Subject: Class 1* Permit Modification Notification Requiring Prior Agency Approval, Waste Isolation Pilot Plant Hazardous Waste Facility Permit Number: NM4890139088-TSDF

Class 1* Permit Modification Notification

Addition of Four New Shielded Containers

**Waste Isolation Pilot Plant
Carlsbad, New Mexico**

Figure A1-37
Range of Typical Shielded Container Dimensions

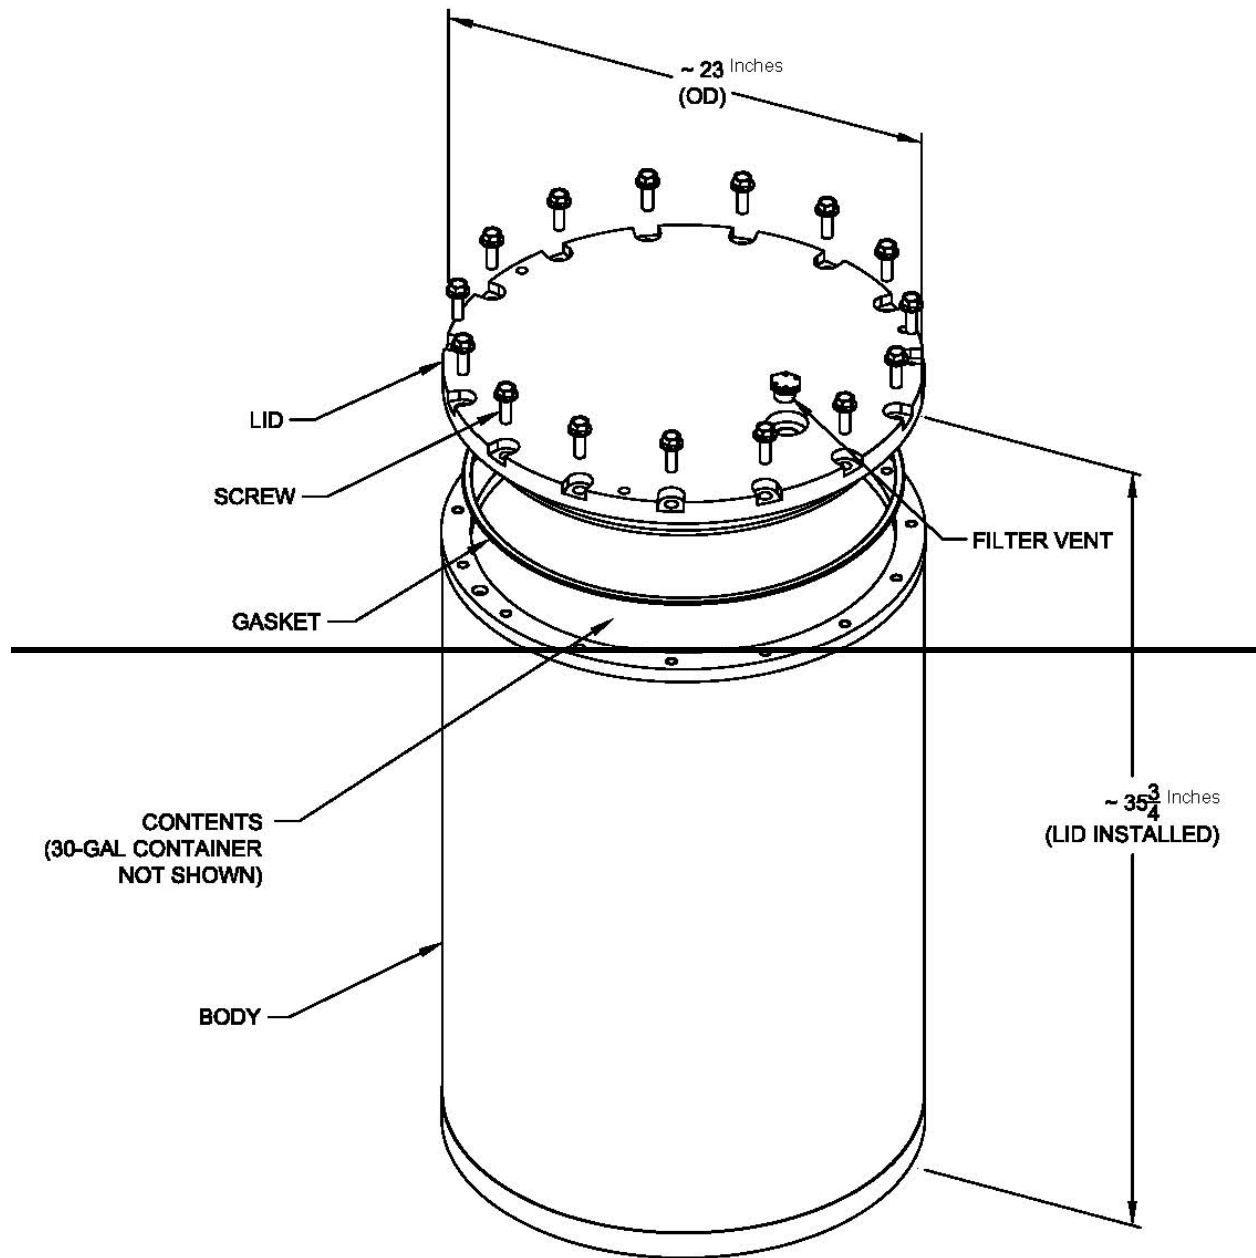
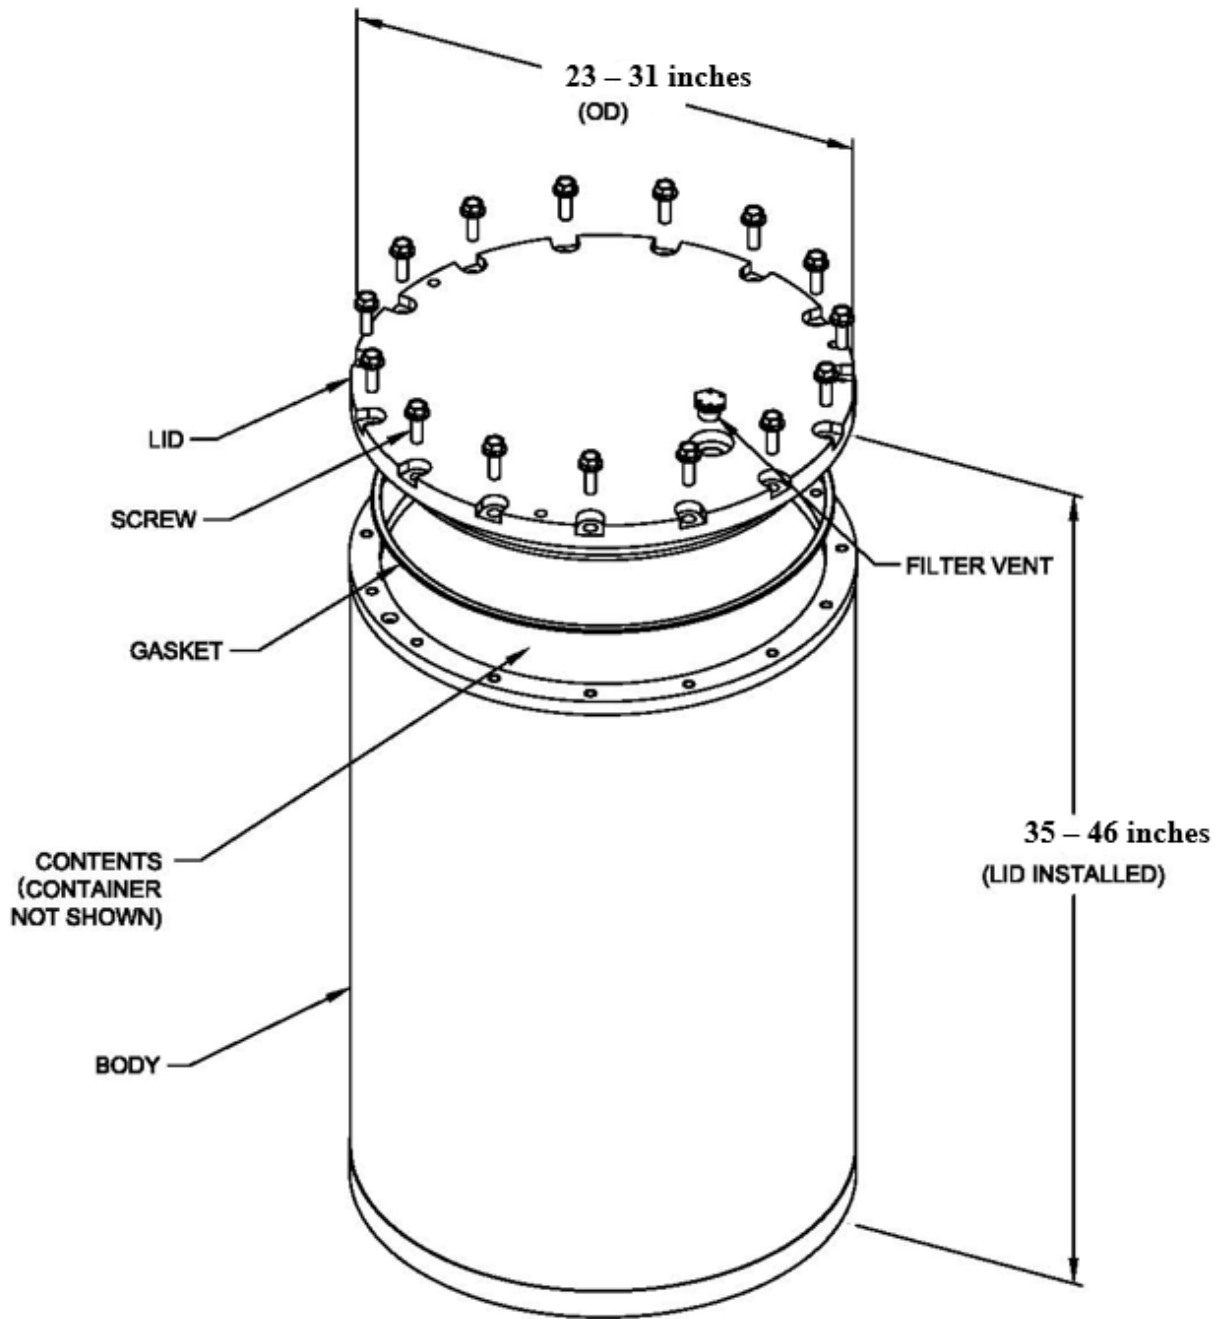
Added a new row to the table to describe the configuration of the SC-55G1 shielded container type including the maximum gross weight of the assembly. Added "Two-pack of shielded containers (SC-55G1)" and "6,820 lbs."
	Added a new row to the table to describe the configuration of the SC-55G2 shielded container type including the maximum gross weight of the single unit. Added "Shielded container single unit (SC-55G2)" and "6,500 lbs."
Permit Attachment A1, Figure A1-37, <i>Typical Shielded Container</i>	Modified Permit Figure A1-37 to include a range of dimensions for the height and outside diameter of typical shielded containers. These ranges encompass the five shielded container types. Changed the outside diameter figure text from "~23 inches" to "23 – 31 inches" and the height from "~35 ³ / ₄ inches" to "35 – 46 inches"
	Modified the [Contents] label by removing the word [30-gal] because the new shielded container types can accommodate 55-gallon drums as well. Changed figure label from "Contents (30-gal container not shown)" to "Contents (container not shown)"

Modified the figure title to clarify that the figure illustrates a range of dimensions to encompass the five different shielded container types. Change Permit text from "Typical Shielded Container" to "Range of Typical Shielded Container Dimensions"

New SC-30G2 Shielded Container and Container Assembly

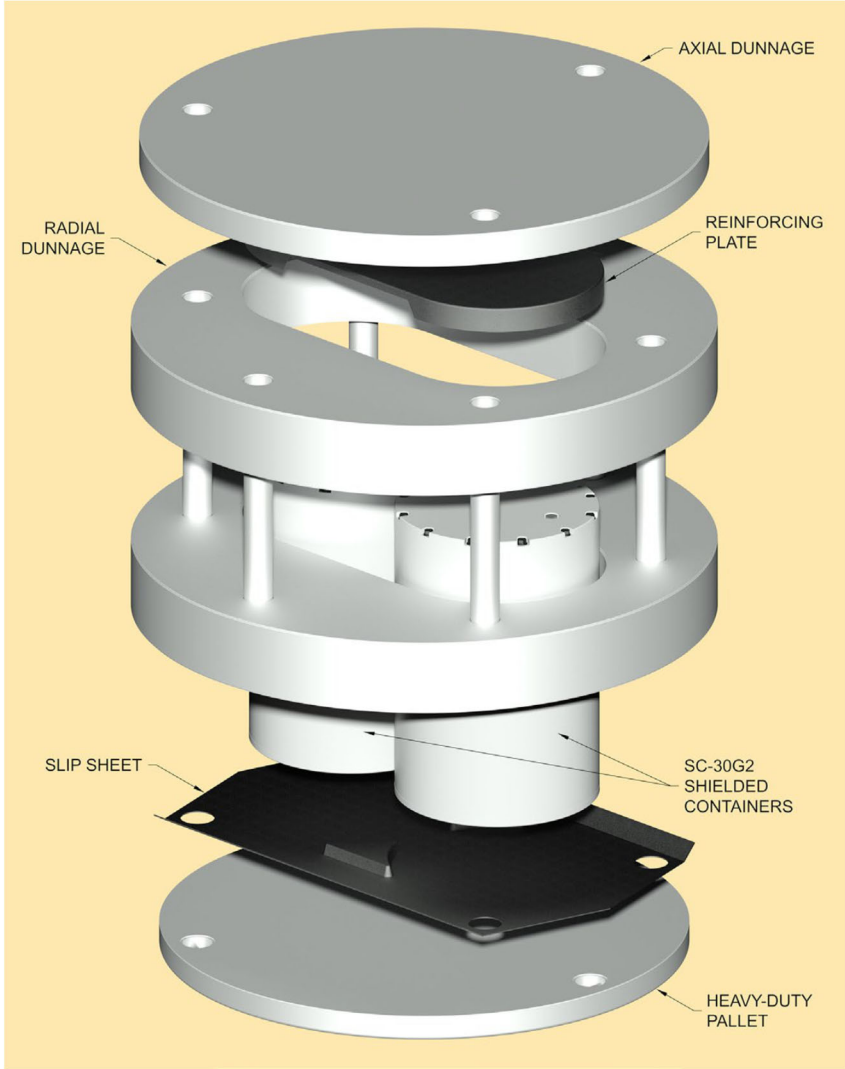
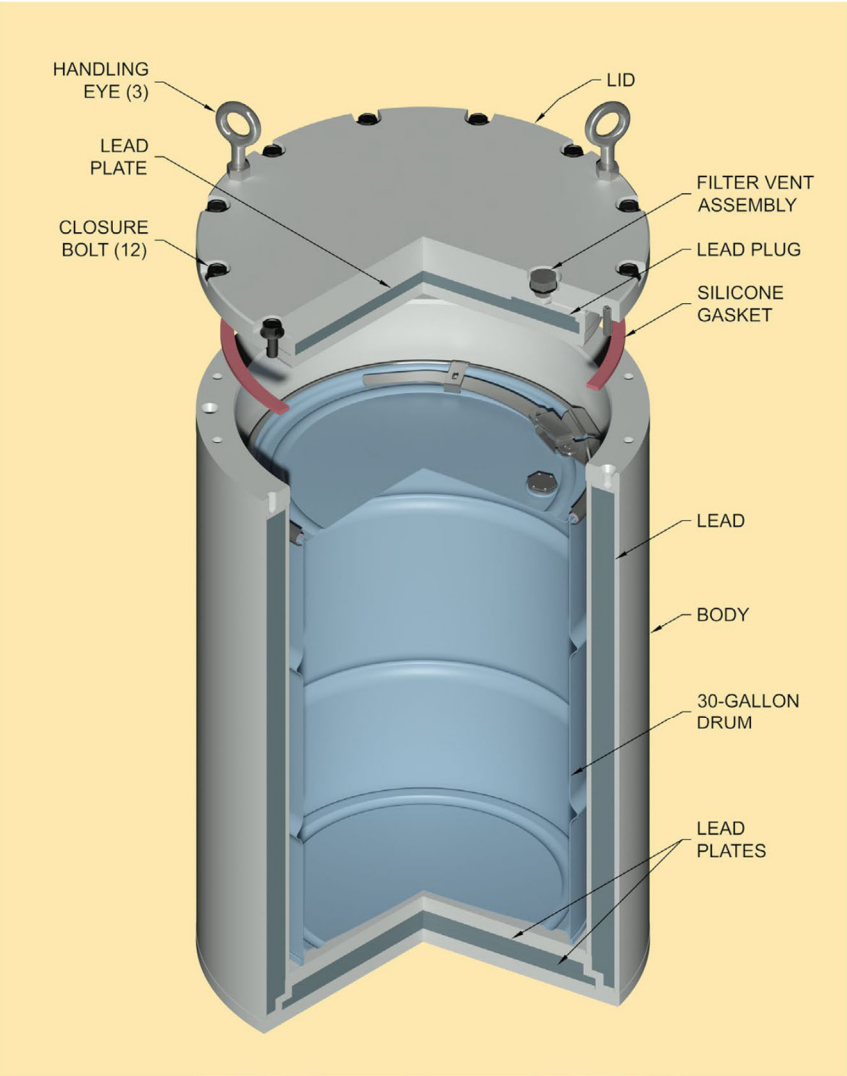
- SC-30G2 Shielded Container
 - The SC-30G2 shielded container has an overall diameter of approximately 24.5-inches (in.) and an overall height of approximately 36.625-in. The SC-30G2 nominally has 1.5-in. (1.40-in. minimum) of lead shielding between 0.30-in. thick inner and outer shells. The shells attach to an upper flange and a 3-in. thick steel base. The base integrates a 21.5-in. diameter, 0.50-in. thick lower lead plate, and a 20-in. diameter, 0.70-in. thick upper lead plate. The 3.89-in. thick steel lid integrates a 19.5-in. diameter, 0.75-in. thick lead plate. The lid also utilizes a 4-in. diameter, 0.25-in. thick lead disk that aligns under the vent port feature. The lid bolts to the container. A gasket of silicone rubber is used for lid closure. The empty weight of the SC-30G2 is approximately 2,610 pounds. The SC-30G2 accommodates a 30-gallon steel drum, which will contain RH TRU mixed waste. The SC-30G2 is configured as a two-pack on a circular pallet surrounded by radial and axial dunnage components and will be transported as a two-pack configuration within the HalfPACT package.

New SC-30G3 Shielded Container and Container Assembly

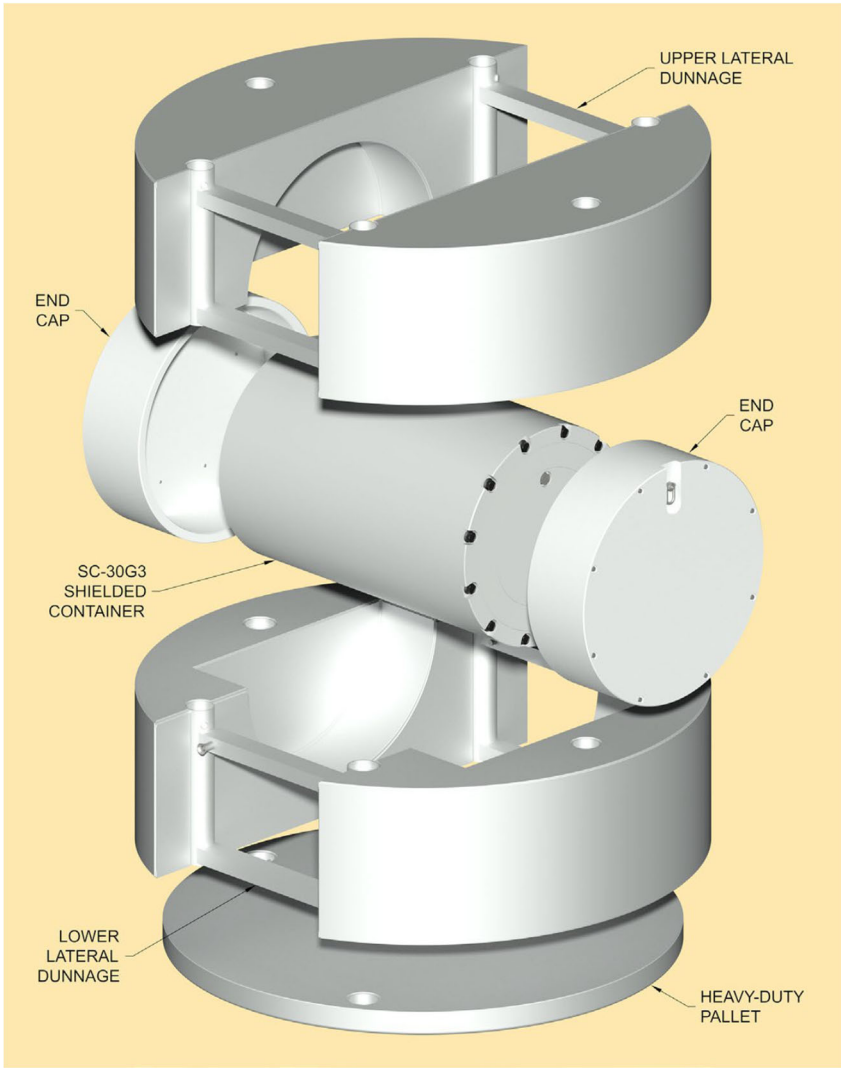
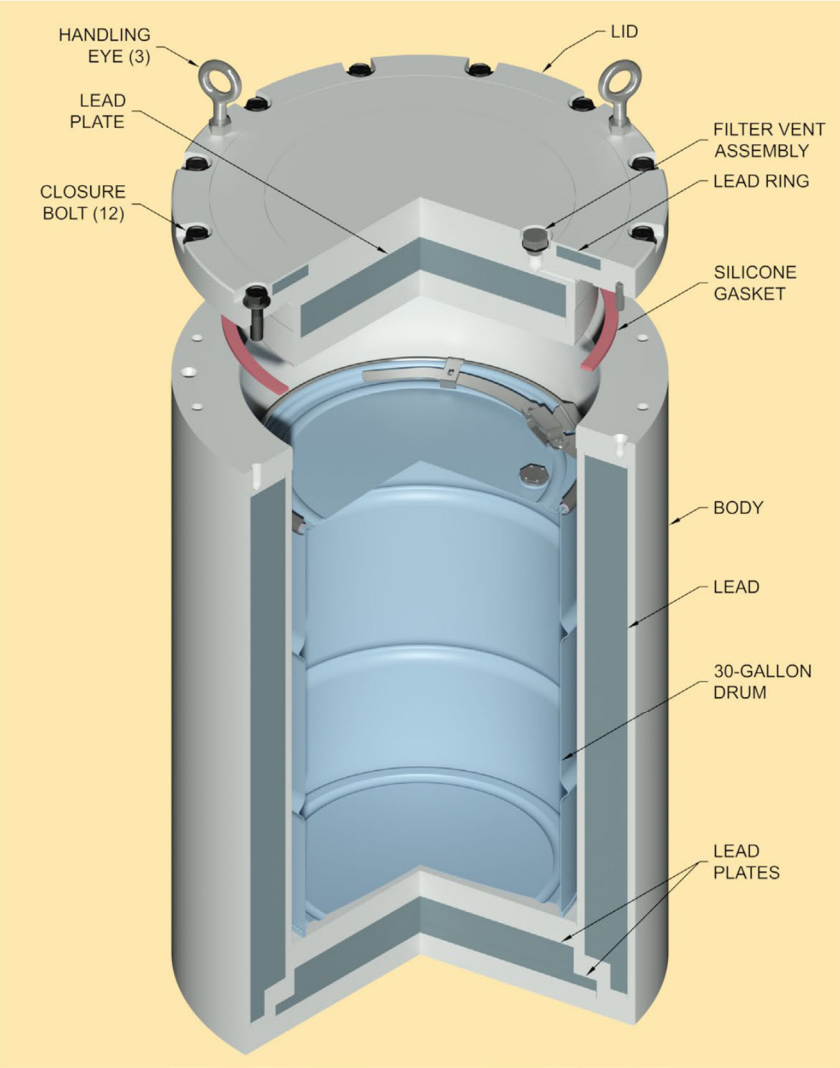
- SC-30G3 Shielded Container
 - The SC-30G3 shielded container has an overall diameter of approximately 28-in. and an overall height of 42.25-in. The SC-30G3 has a 2.75-in. minimum of lead shielding between 0.50-in. thick inner and outer shells. The shells connect to an upper flange and a 5.75-in. thick steel base. The base integrates a 23-in. diameter, 0.75-in. thick lower lead plate, and a 20-in. diameter, 1.75-in. thick upper lead plate. The 6.79-in. thick steel lid integrates a 19-in. diameter, 2.25-in. thick lead plate. The lid also integrates a 23.5-in. outside diameter, 17.75-in. inside diameter, 0.75-in. thick lead ring. The lid is bolted to the container. A gasket of silicone rubber is used for lid closure. The empty weight of the SC-30G3 is approximately 5,750 pounds. The SC-30G3 accommodates a 30-gallon steel drum, which will contain RH TRU mixed waste. The SC-30G3 is configured as a lateral single unit on a circular pallet surrounded and supported by upper

and lower lateral dunnage components and will be transported as one single unit within the HalfPACT package.

New SC-55G1 Shielded Container and Container Assembly

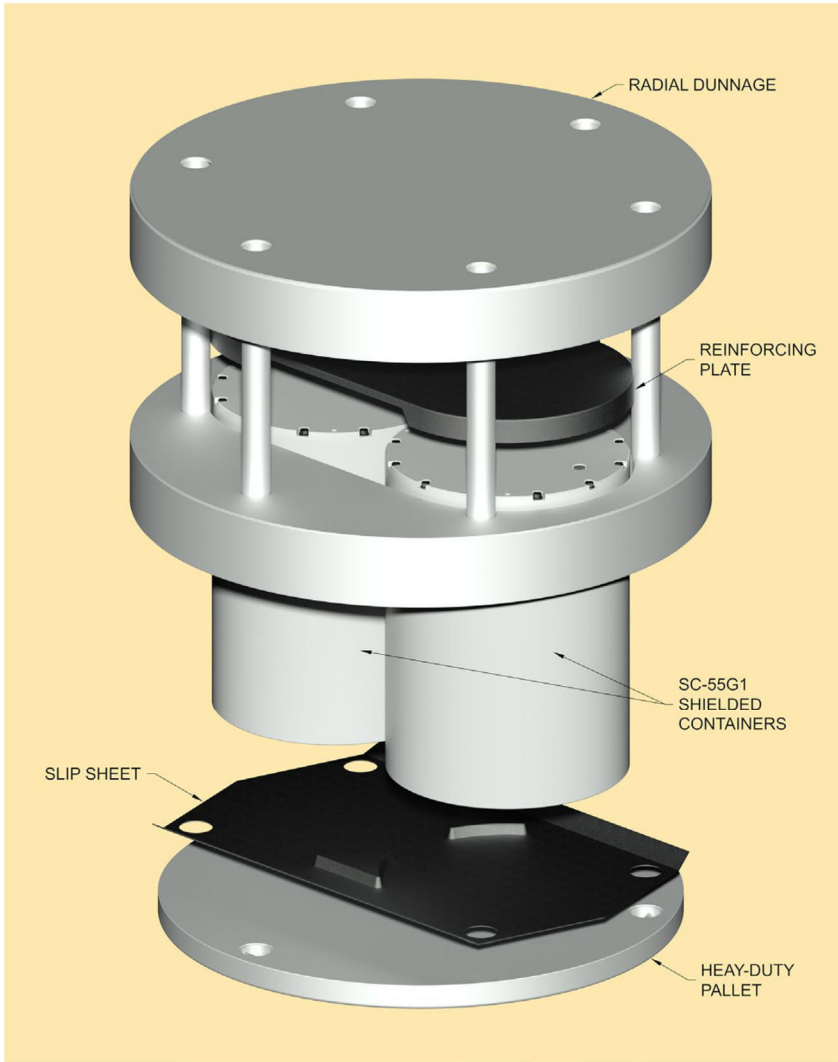
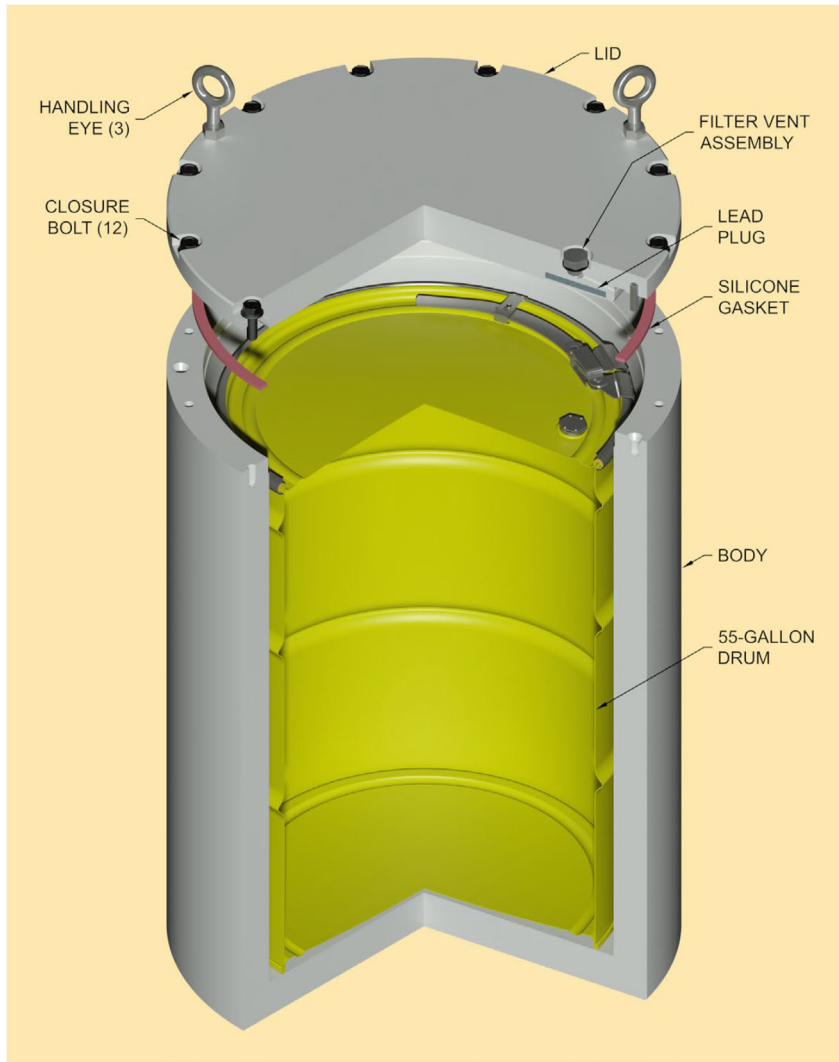
- SC-55G1 Shielded Container
 - The SC-55G1 shielded container has an overall diameter of approximately 29.375-in. and an overall height of approximately 40.5-in. The 2.20-in. thick sidewall connects to a 2.35-in. thick steel base. The 2.40-in. thick steel lid integrates a 4-in. diameter, 0.40-in. thick lead disk that is aligned under the vent port feature. The lid is bolted to the container. A gasket of silicone rubber is utilized for lid closure. The empty weight of the SC-55G1 is approximately 2,810 pounds. The SC-55G1 accommodates a 55-gallon steel drum, which will contain RH TRU mixed waste. The SC-55G1 is configured as a two-pack on a circular pallet surrounded by radial dunnage components and will be transported as a two-pack configuration within the HalfPACT package.
